Testimony to the Planning and Sustainability Commission on the Design Overlay Zone Amendments, Proposed Draft

RE: DOZA Proposed Design Standards and Citywide Design Guidelines.

Map 420-4

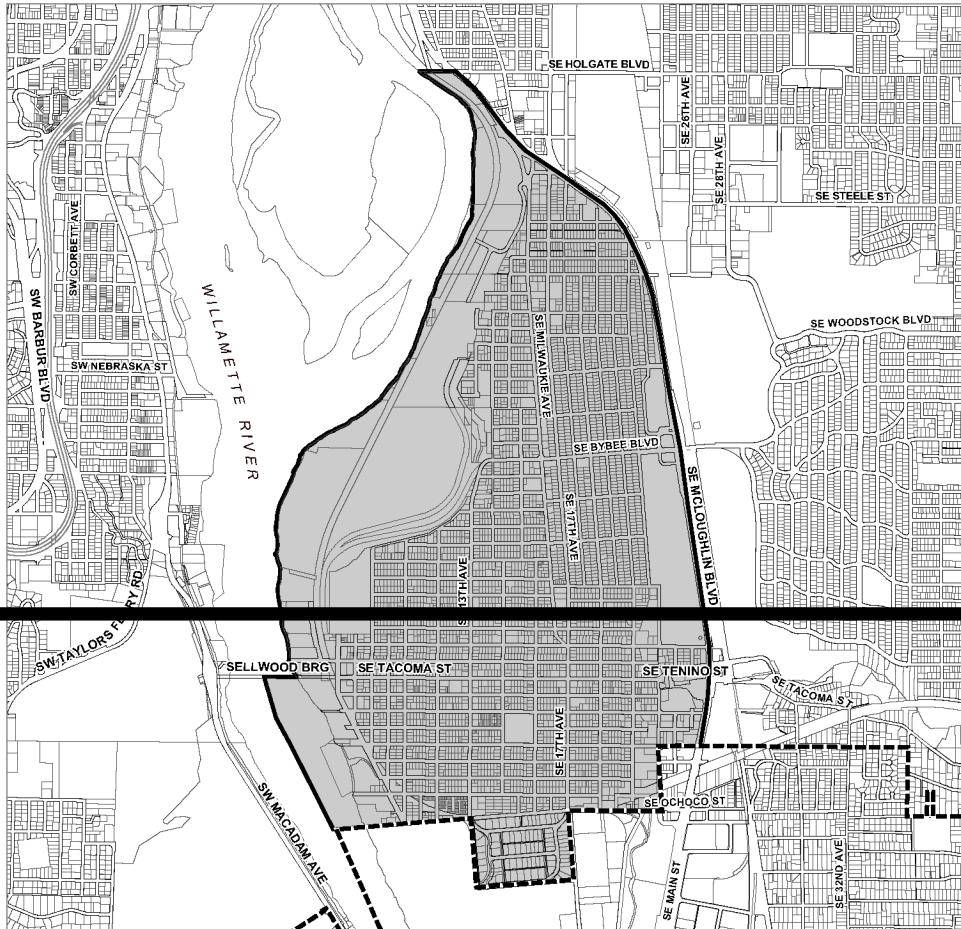
I agree with and support the proposed Design Standard additions to the PDX Main Street Design Features from the official comments by the Sellwood Moreland Improvement League (SMILE) submitted November 9, 2019. These standards are 1) the Sellwood Moreland Main Street Design Guidelines which are currently in development, and 2) the Centers Main Street Overlays. These standards could be implemented in the Design District which should be retained, not eliminated as is proposed in Volume 2, p. 73, map 420-4.

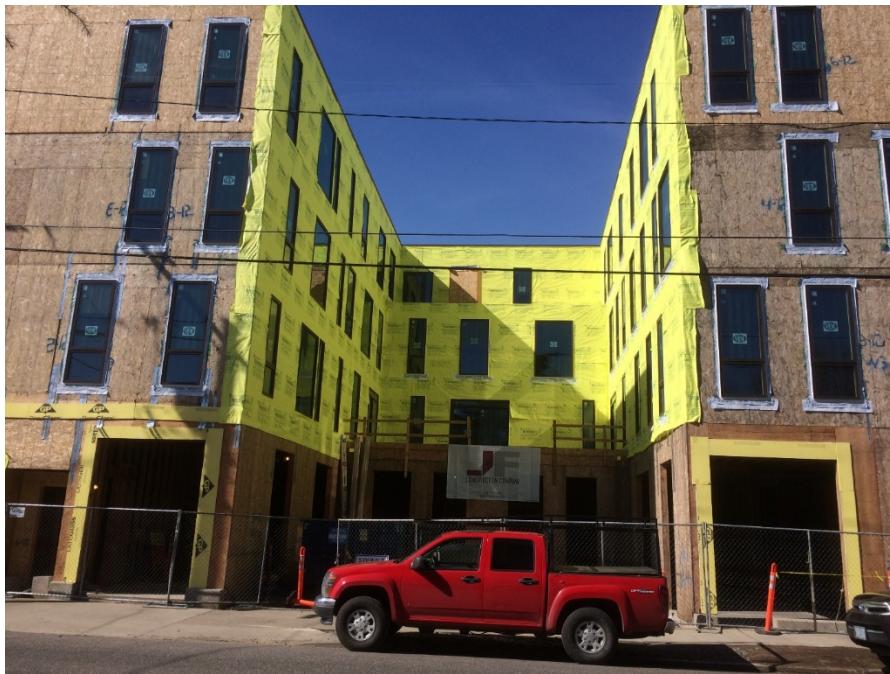
Photo 5b. A private outdoor courtyard with surrounding building on 4 sides, adjacent building above not shown and no photo possible. Standard QR8 would provide points for a space hidden from the public. 8222 SE 6th Ave.

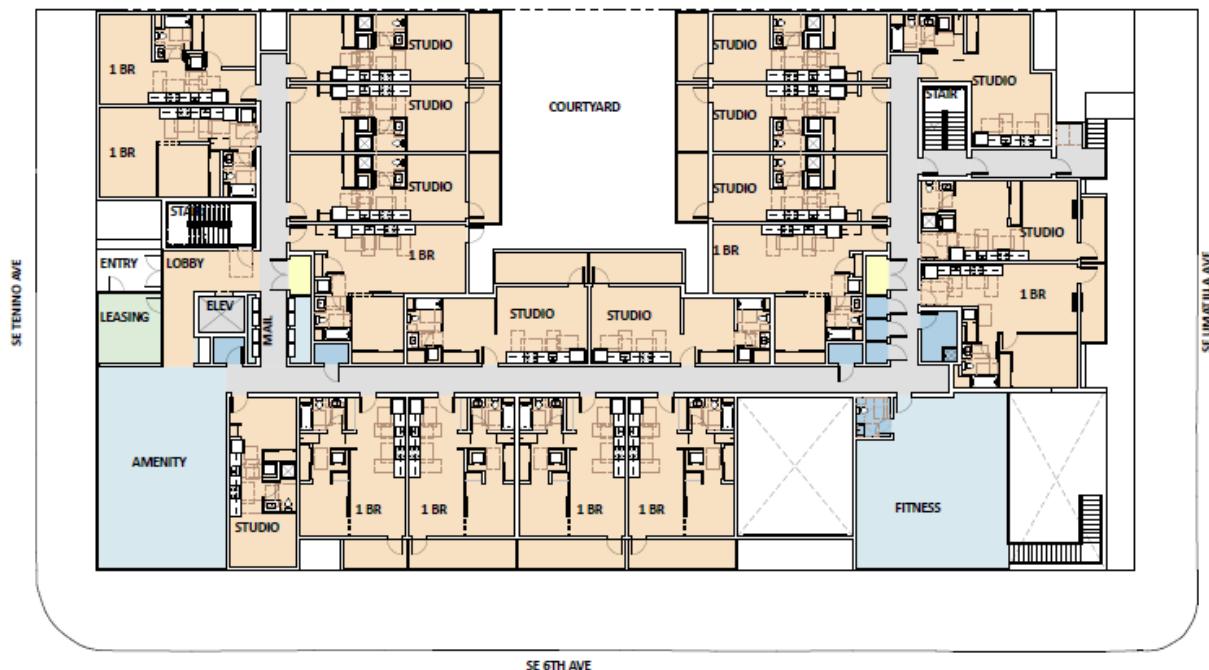
Photo 6. A gas meter for a new building along a busy commercial sidewalk at the corner of SE 13th and Spokane. We support screening of utility meters required by PR18.
